Minutes of the meeting of the Planning Committee held at Banwell Youth & Community Centre, 7pm on Monday 3rd November 2025.

25/P/2287/FUH 10 Hill Path Banwell BS29 6AB

Dec Planning Powerpoint

25/P/2230/FUH The Withies Riverside Banwell BS29 6EH

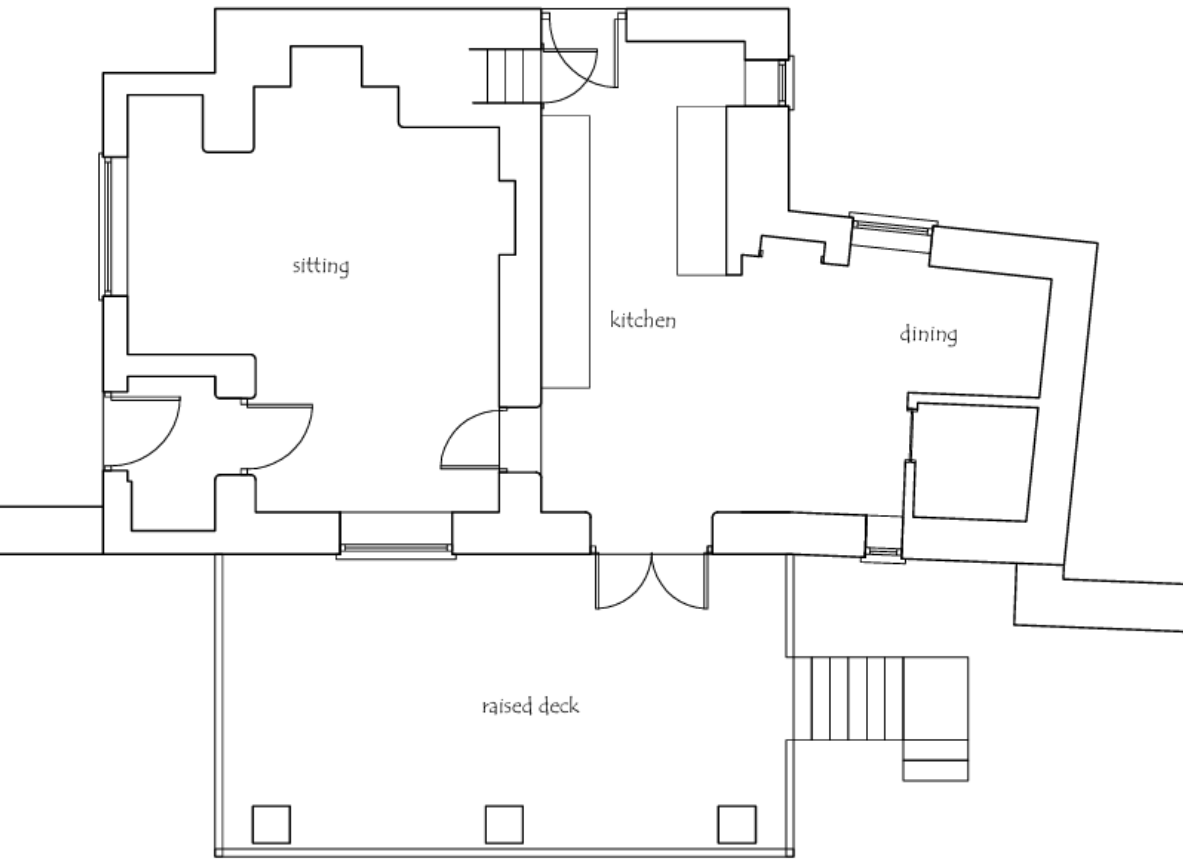
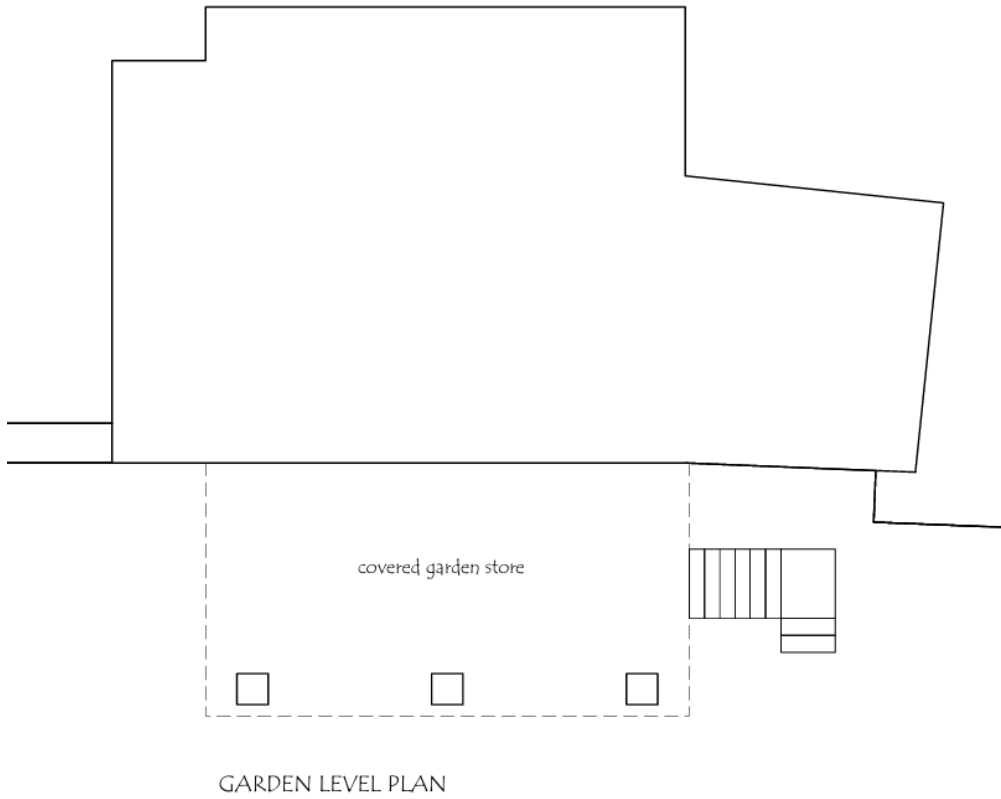
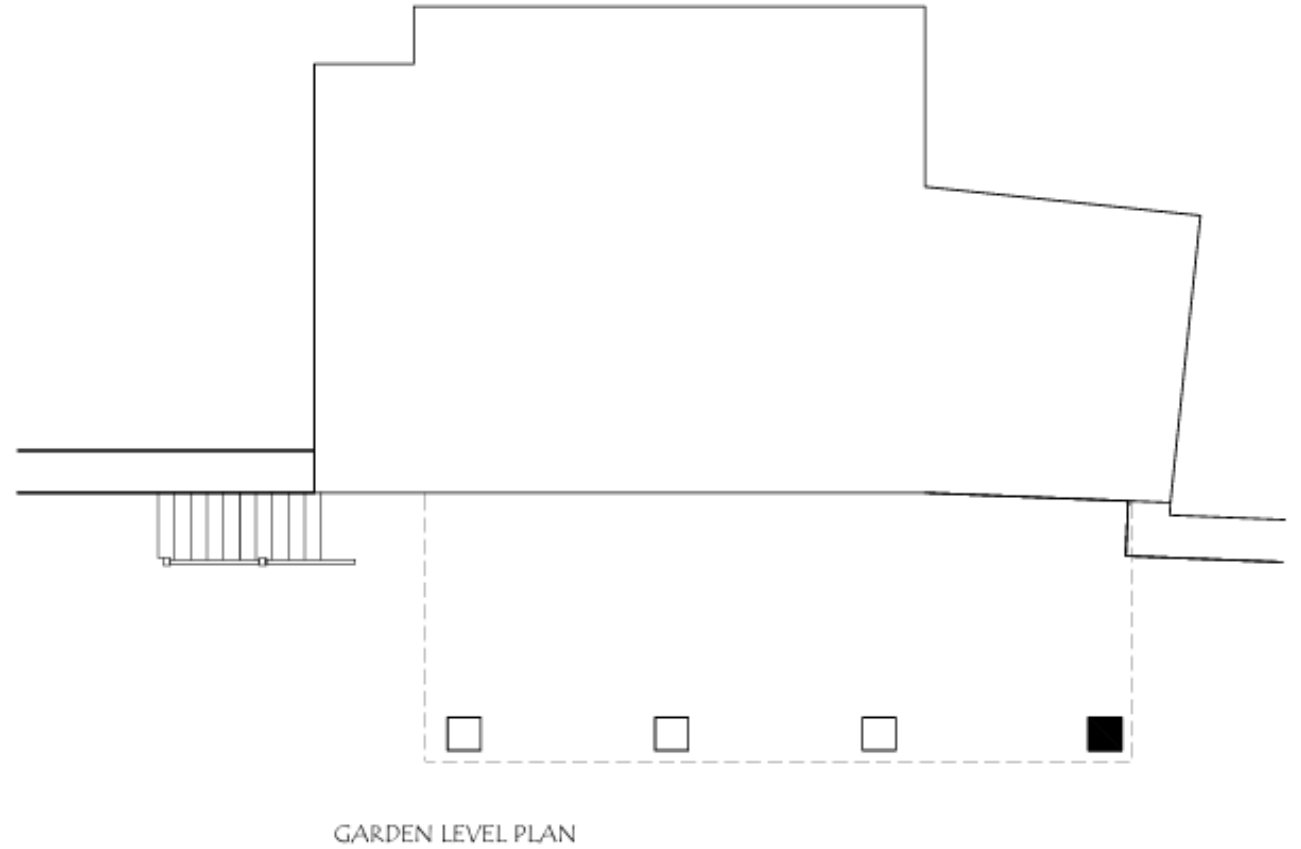
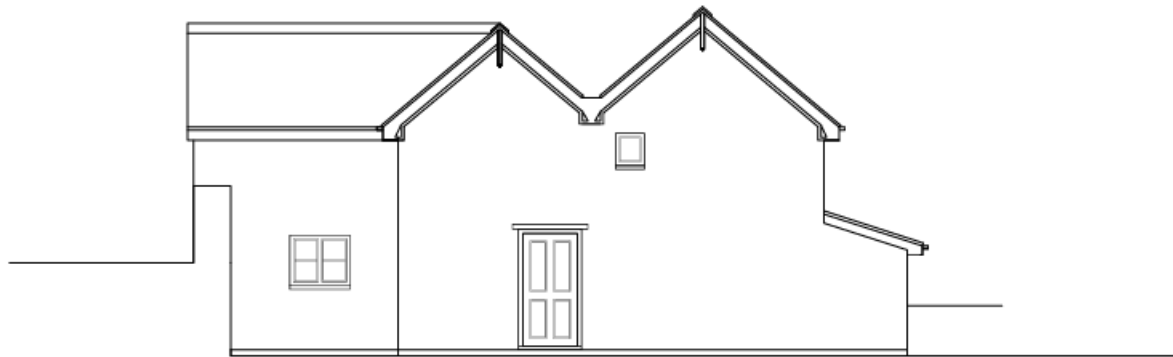
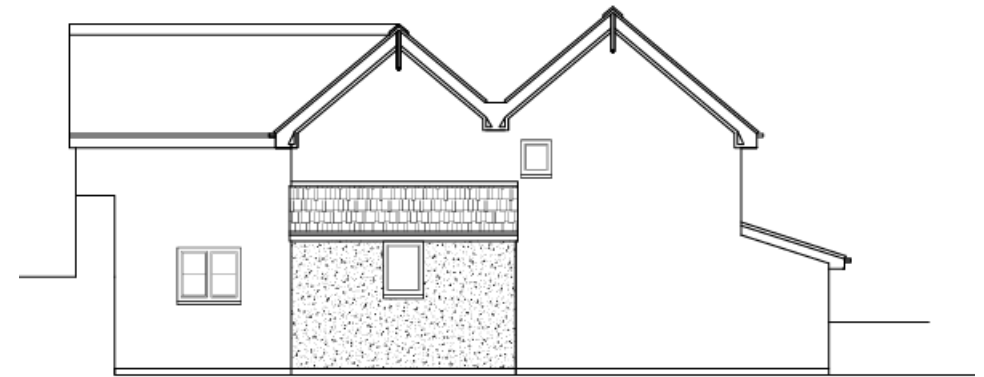
Topic	Previous Environment and biodiversity comments	Recommendation
Energy Efficiency	<p>The proposed extension is to be constructed using composite cladding or stained timber boarding and a flat roof and there is no mention of insulation being incorporated . The Council encourages the applicant to consider high-performance materials to support energy-efficient and sustainable design in line with NPPF paragraph 167.</p>	<p>To recommends that the applicant incorporates measures to improve energy efficiency , such as quality insulation and energy-efficient windows to ensure the extension aligns with NPPF paragraph 167.</p>
Lighting	<p>Due to being within Zone B of the North Somerset and Mendip Bats SAC and within a wooded area, construction should avoid the use of artificial lighting to prevent disturbance to bats. This ensure compliance with the Conservation of Habitats and Species Regulations 2017 and the North Somerset and Mendip Bats SAC without the need for additional surveys or lux control plans.</p>	<p>All construction works shall be carried out only during daylight hours. No external lighting shall be installed as part of the development unless a separate planning application is submitted to and approved by the Local Planning Authority</p>

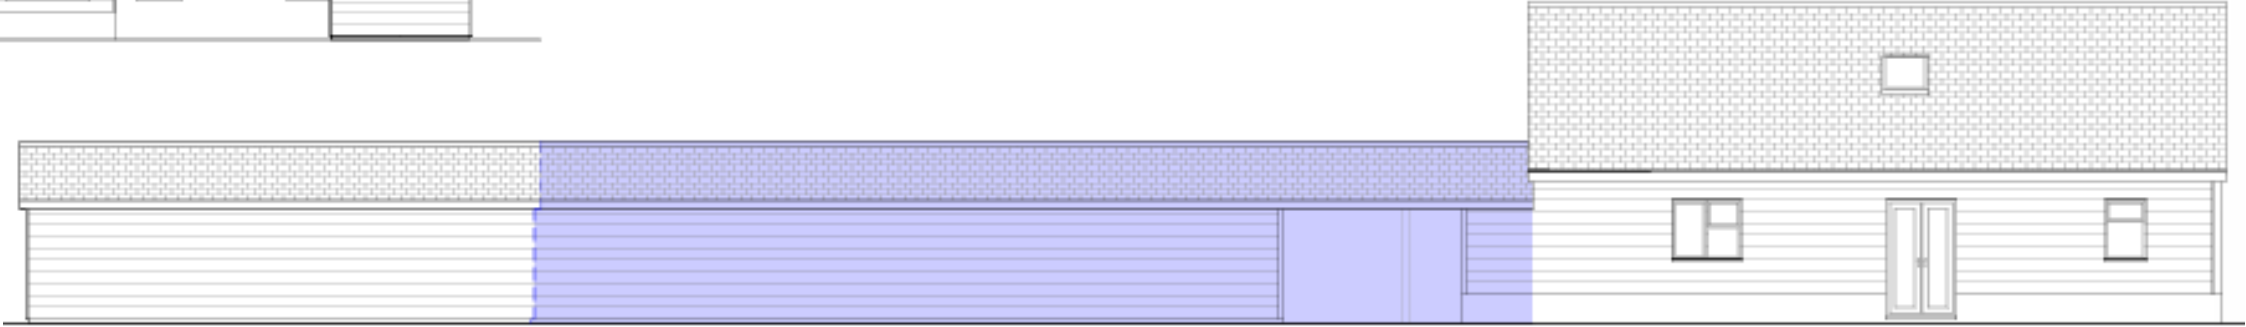
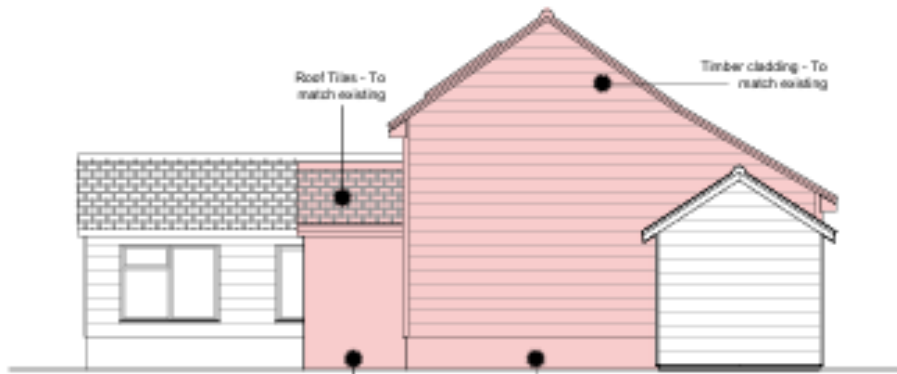
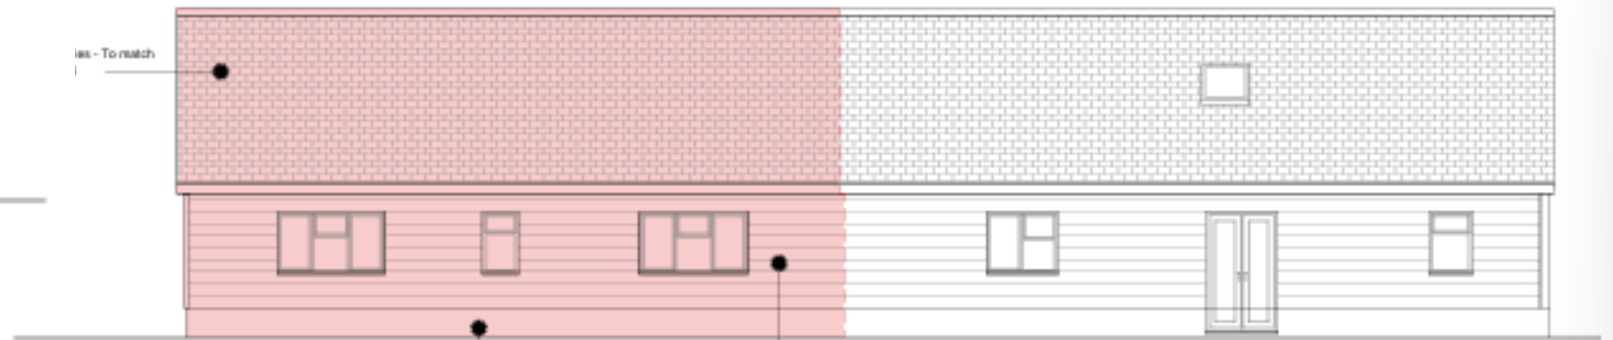
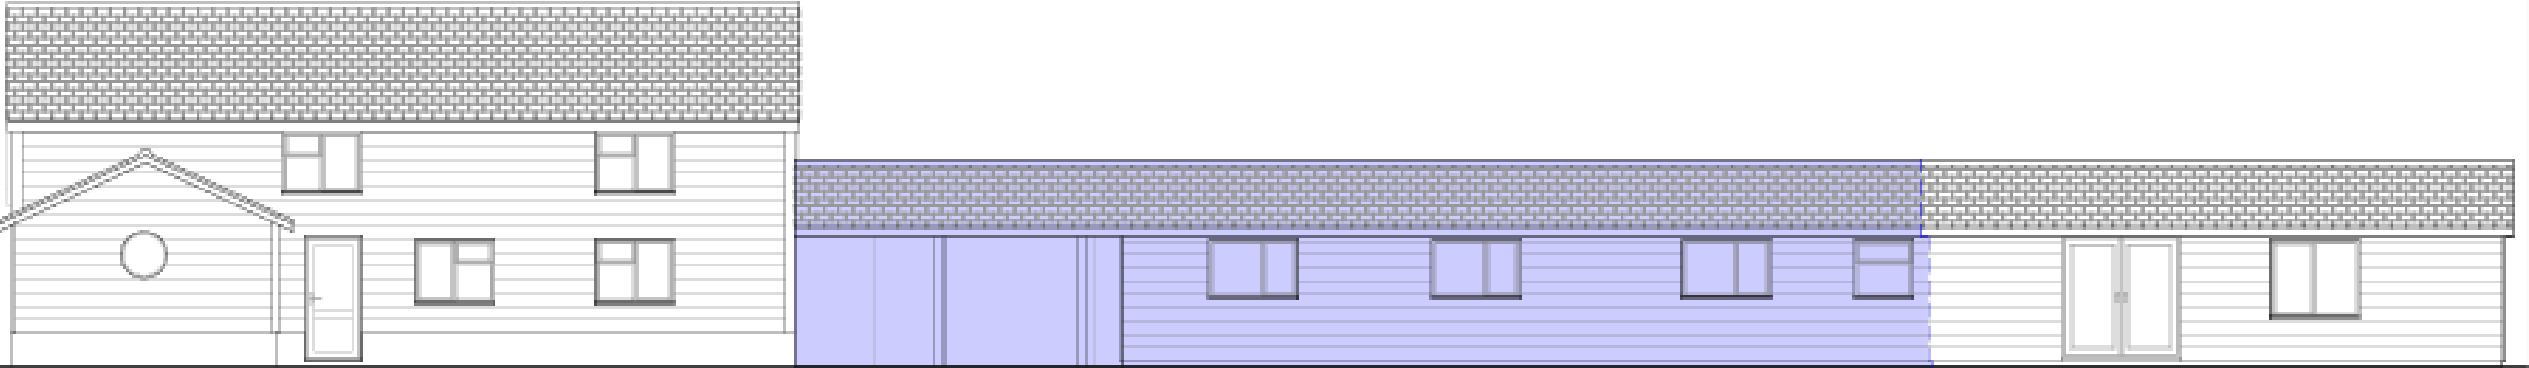
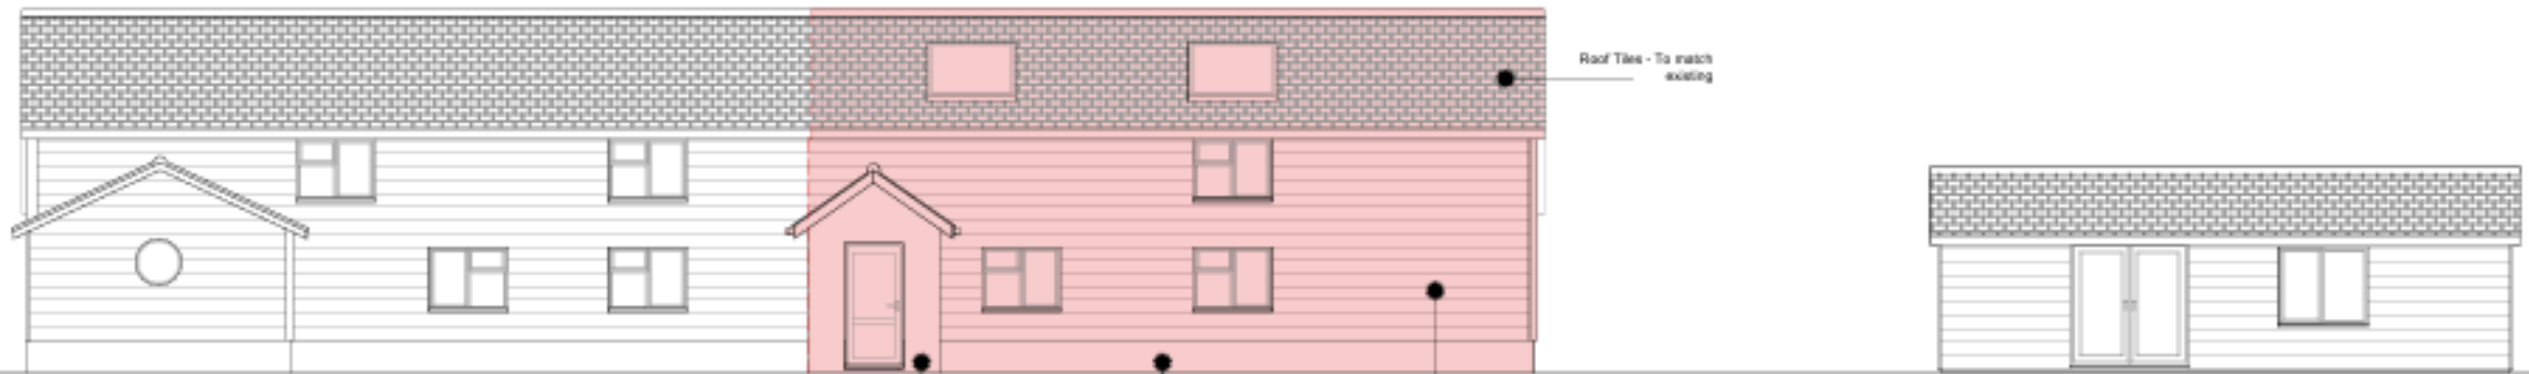
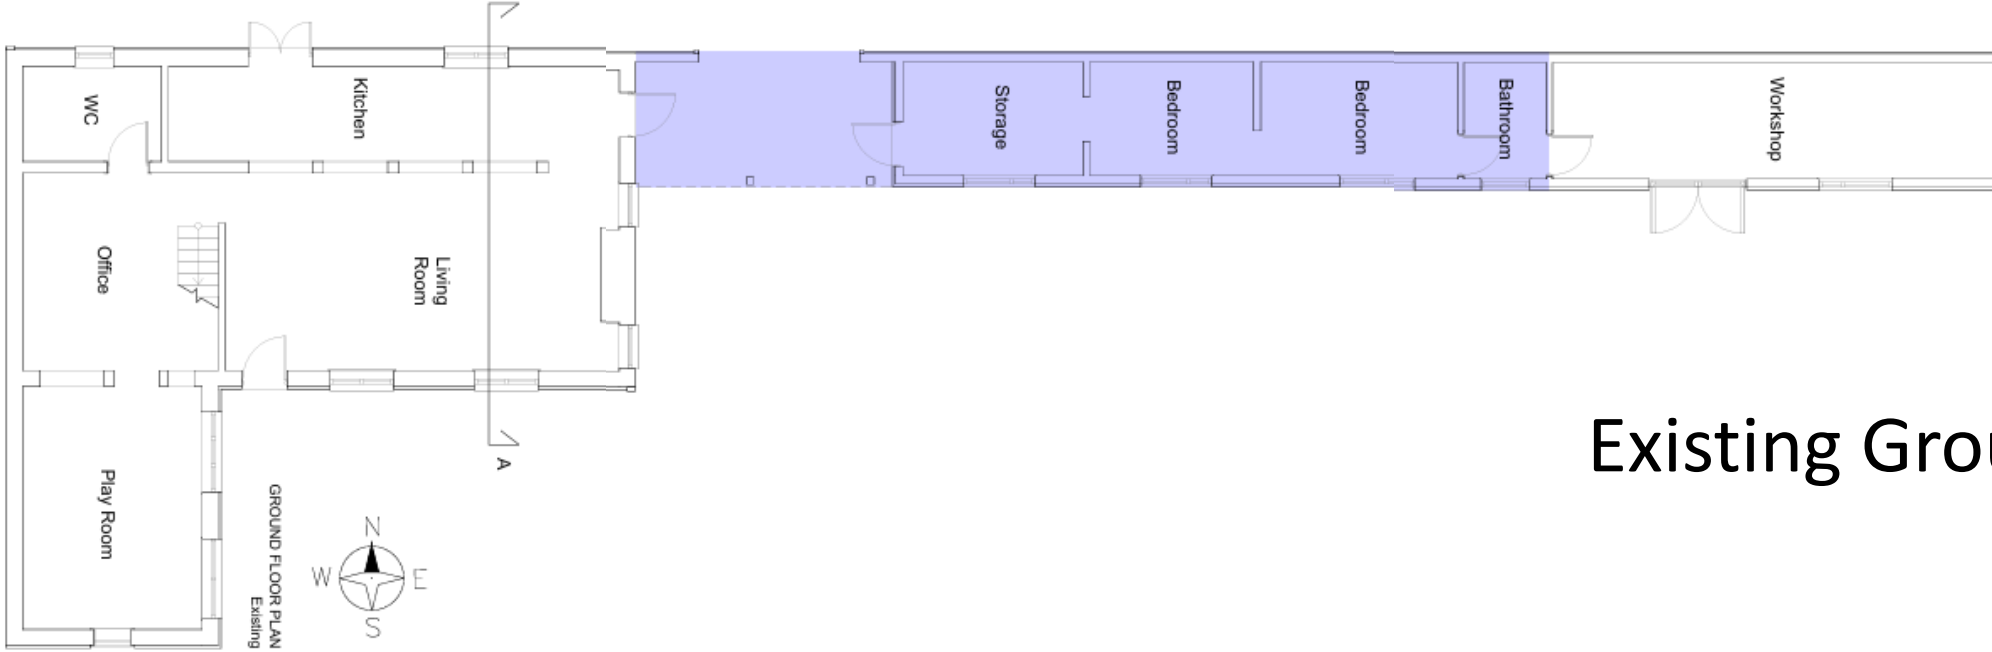
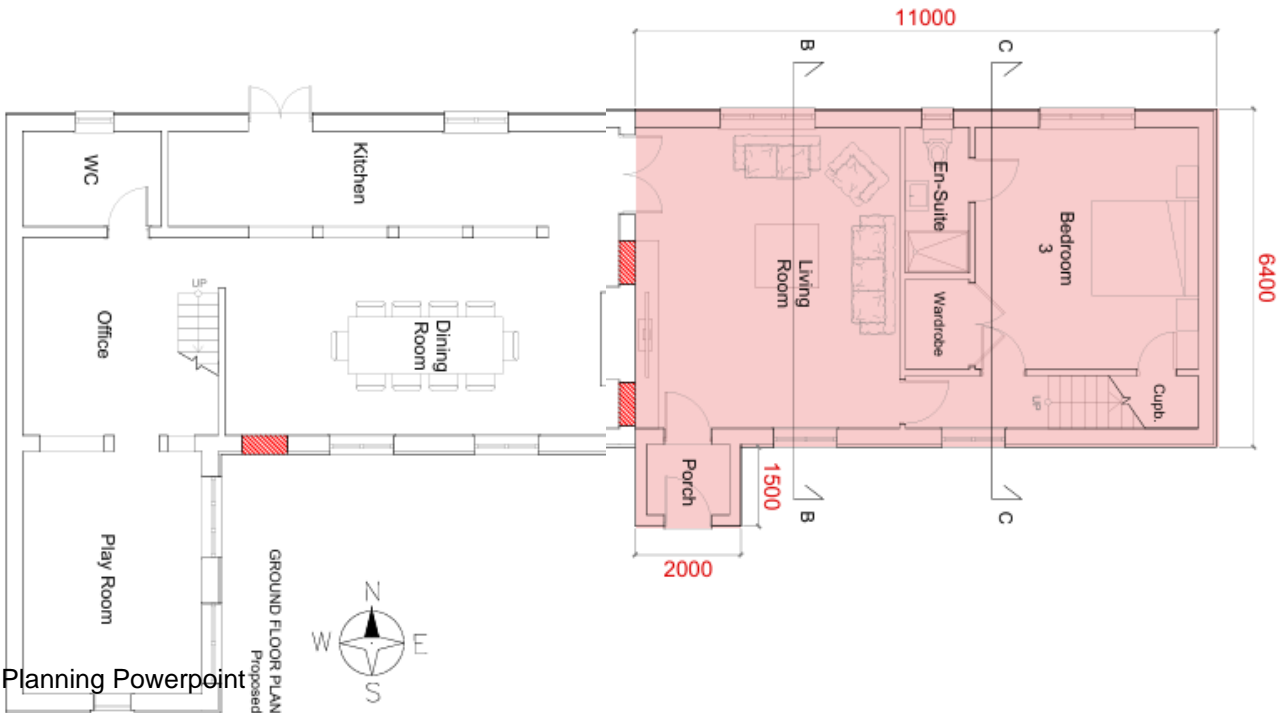
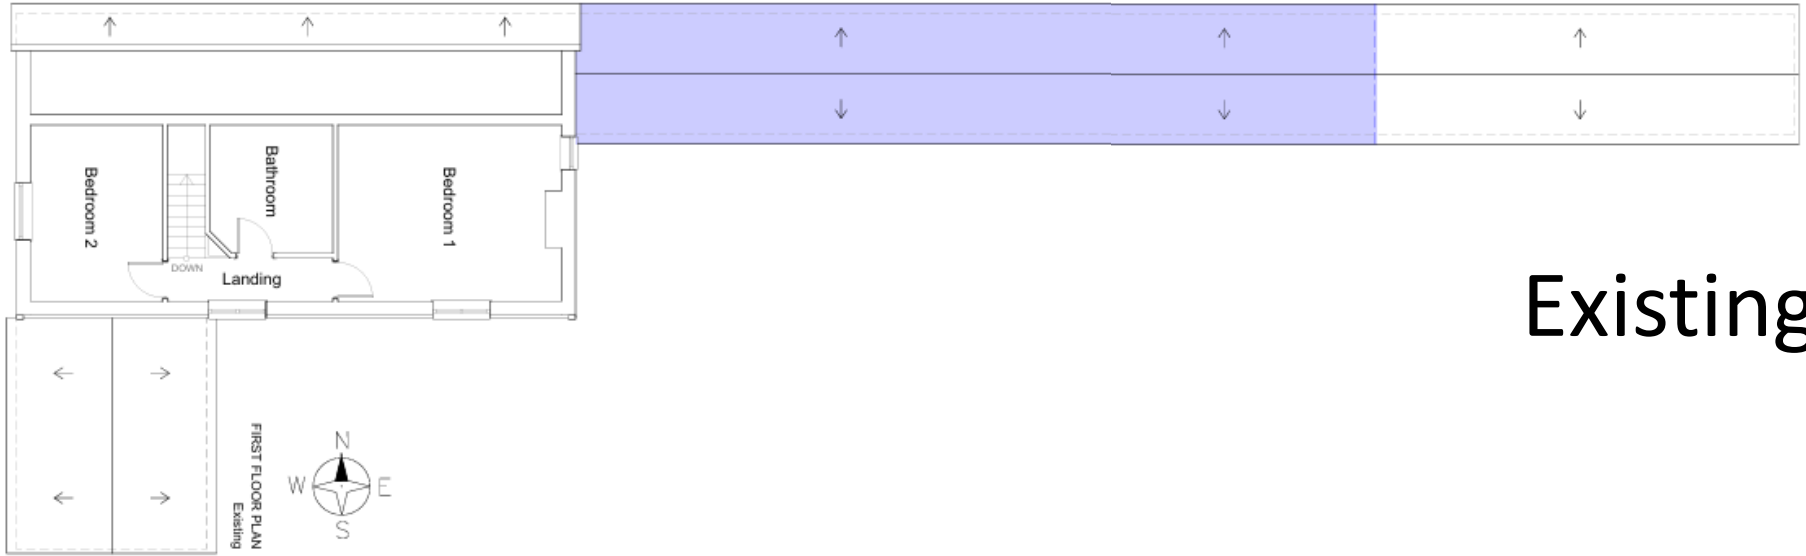
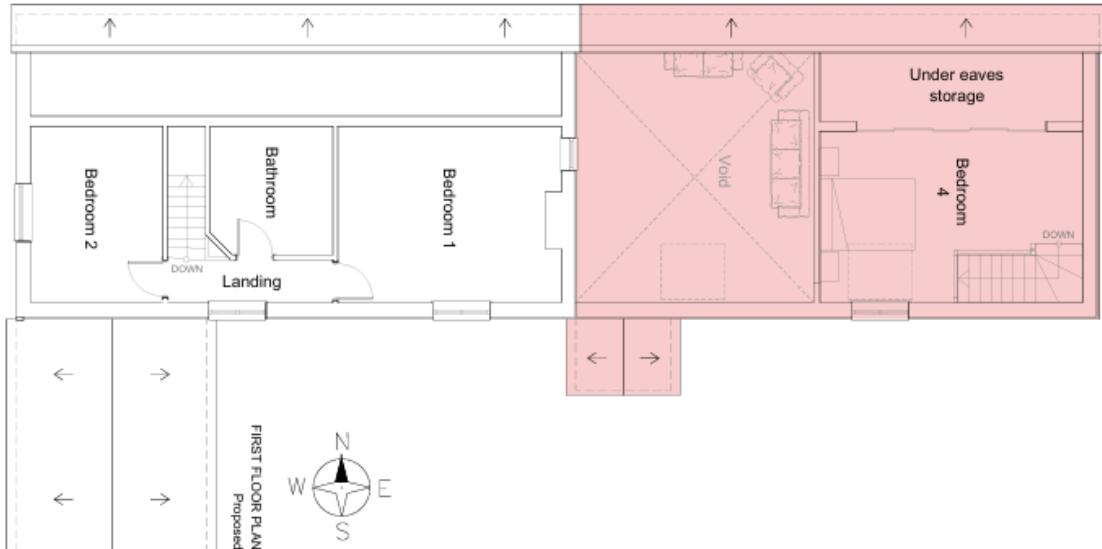
Topic	Previous Environment and biodiversity comments	Recommendation
Sustainable Design	In line with North Somerset Core Strategy Policy CS2: Delivering Sustainable Design and Construction, all new development is expected to demonstrate a commitment to sustainable design and resource efficiency. The proposed conversion includes a new bathroom and utility, which provides an opportunity to integrate eco-friendly fittings and finishes that will reduce both water and energy consumption.	That the applicant be encouraged to incorporate sustainable fittings, such as low-flow taps and dual-flush toilets, if installing new bathroom fixtures
